UNITED STATES PATENT AND TRADEMARK OFFICE

APPLICATION NO.	FILING DATE	FIRST NAMED INVENTOR	ATTORNEY DOCKET NO.	CONFIRMATION NO.
10/034,853	12/28/2001	Neal J. Middelberg	1174/1172	9621
25297	7590	04/08/2004	EXAMINER	
JENKINS & WILSON, PA 3100 TOWER BLVD SUITE 1400 DURHAM, NC 27707			SCHLAK, DANIEL K	
			ART UNIT	PAPER NUMBER
			3653

Office Action Summary

DETAILED ACTION

The following two pages comprise excerpts from the reference, namely figures 1 and 2 of Rastorguyeff, to aid applicant in understanding the nature of the rejection.

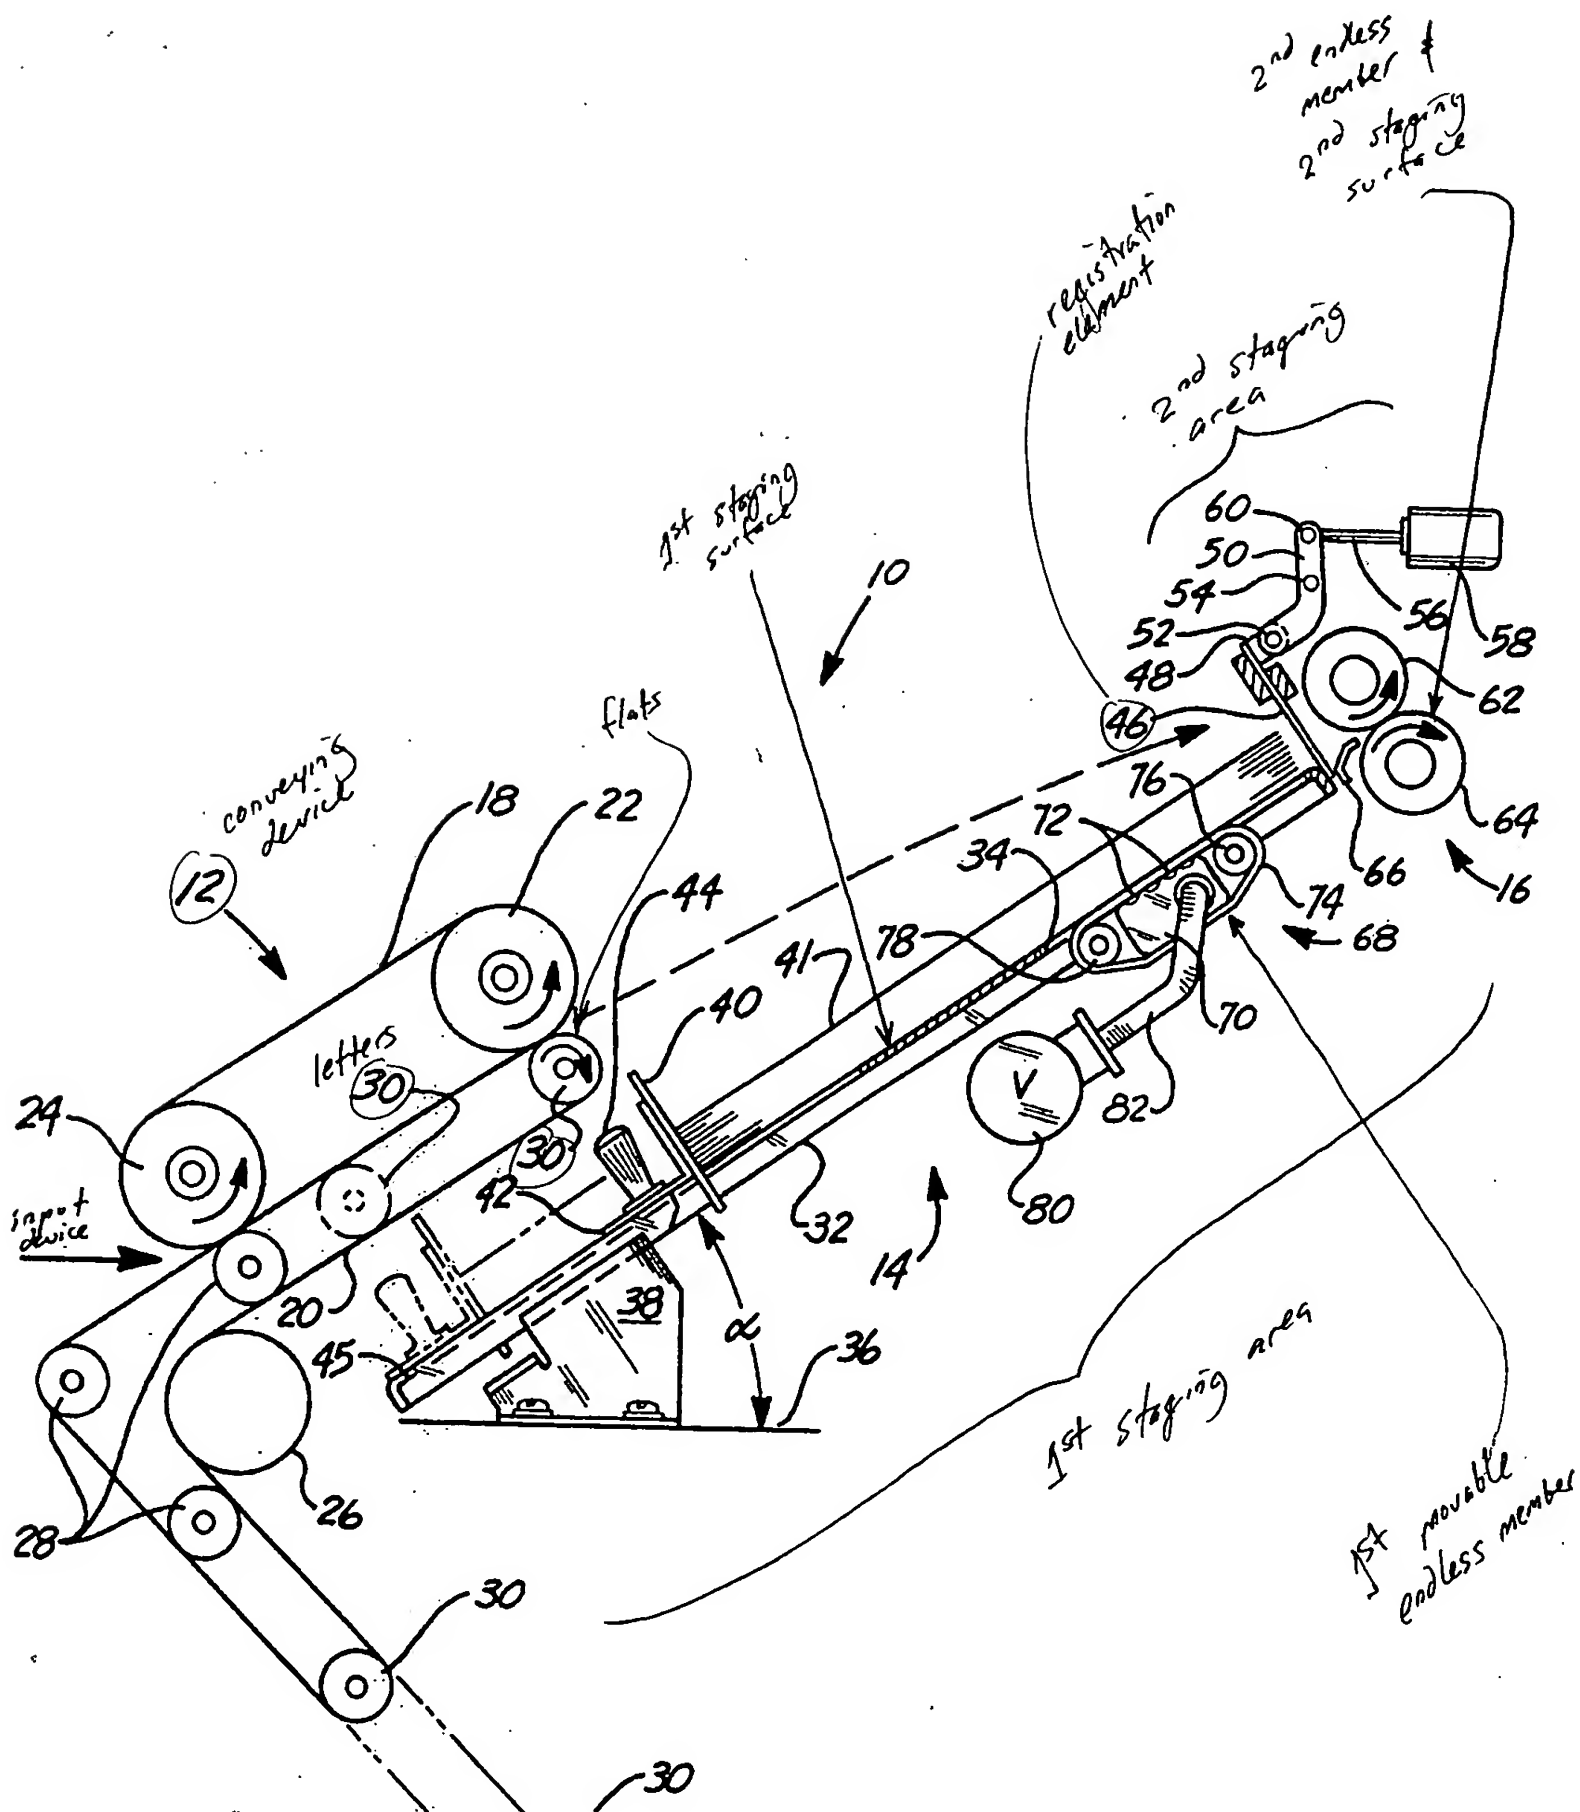
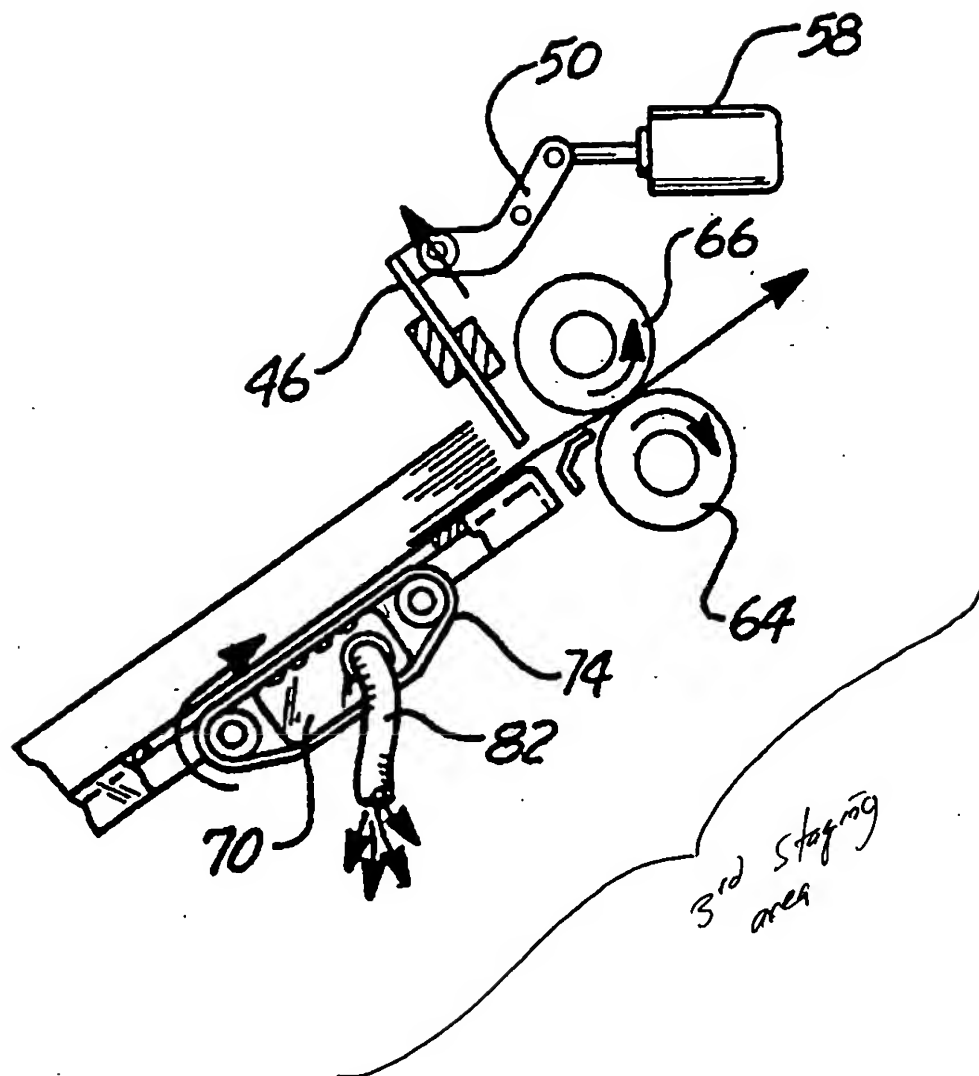
Rastorguyeff teaches a collector apparatus adapted for handling flat and letter units, the apparatus comprising a first staging area comprising a first staging surface and a first stage transport assembly, a second staging area generally disposed downstream from the first staging area, the second staging area comprising a second staging surface and a second stage transport assembly, a third staging area comprising at least a portion of the second stage transport assembly, and a conveying device adjustable between a flats mode position and a letters mode position, wherein in the letters mode position, a first material flow path is defined through the first and second staging areas, and in the flats mode position, a second material flow path is defined through the third staging area. The first stage transport assembly comprises a movable first endless member. The second stage transport assembly comprises a second endless member. The conveying device comprises a retractable first conveying assembly, the retractable first conveying assembly is extended over at least a portion of the first staging surface in the flats mode position of the conveying device, and the

retractable first conveying assembly is retracted to expose the first staging surface in the letters mode position. The retractable first conveying assembly comprises a movable first endless belt, the movable endless belt is extended over at least a portion of the first staging surface in the flats mode position of the conveying device, and the movable first endless belt is retracted to expose the first staging surface in the letters mode position.

An input device operatively communicates with an upstream end region of the first staging area in the letters mode position, and operatively communicates with an upstream end region of the third staging area through the conveying device in the flats mode position. The retractable first conveying assembly comprises a first rotatable element, the first rotatable element disposed at an upstream end region of the first staging area in the letters mode position, and alternatively disposed at a downstream end region of the first staging area in the flats mode position. The retractable first conveying assembly comprises a first endless belt movable about the first rotatable element. The retractable first conveying assembly comprises a second rotatable element disposed at first elevation in the letters mode position, and alternatively disposed at a second elevation in the flats mode position, and wherein the second elevation is higher than the first elevation. The retractable first conveying assembly comprises a first endless belt movable about the first and second rotatable elements. The conveying device comprises a second conveying assembly, the first conveying assembly includes a movable first endless belt, the second conveying assembly

includes a movable second endless belt, and the second material flow path runs between the first and second endless belts. An input device operatively communicates with an upstream end region of the first staging area in the letters mode position, and operatively communicating with an upstream end region of the third staging area through the first and second endless belts in the flats mode position.

The conveying device comprises a material unit guiding component adjustable between the flats mode position and the letters mode position, and wherein, in the letters mode position, the guiding component is disposed at a first elevation at which the guiding component is adapted to at least partially define the first material flow path, and in the flats mode position, the guiding component is disposed at a second elevation higher than the first elevation.

The conveying device comprises a material unit guiding component adjustable between the flats mode position and the letters mode position, and wherein, in the letters mode position, the guiding component is disposed at a first elevation at which the guiding component is adapted to at least partially define the first material flow path, and in the flats mode position, the guiding component is disposed at a second elevation higher than the first elevation. The apparatus further comprises an input device an upstream end region of the first operatively communicating with staging area in the letters mode position, and operatively communicating with an upstream end region of the third staging area through the conveying device in the flats mode position. The input device is supposed by an upstream material unit processing device. An output device is taught operatively communicating with a downstream end of the second staging area.

Figure 2 has been included to show the extent of the third staging area.

In both rejections under 35 U.S.C. 102, Applicant is reminded that the third staging area, in the instant application and in the references, is nothing more than most of the first staging area and part or most of the second staging area. No liberties have been taken in interpreting it thus, as Applicant has done exactly this. Thus, no matter what the flow path, it necessarily passes through all three flow paths all the time. The movable/retractable first conveying assembly, and what it comprises or how it acts, does not change the existence of the staging areas and how they are interpreted, particularly since the instant application is an improvement on '453. In other words, since '453 teaches everything of the claims rejected under it, including a retractable first conveying assembly that is shown clearly capable of adjustment up and down, one of

In other words, the retractable first conveying assembly of the claims must be further defined to not read on the adjustable elements (52A, 52B, 52C) of the '453 reference, and the flow paths and/or staging areas must be further defined to not read on Rastorguyeff.
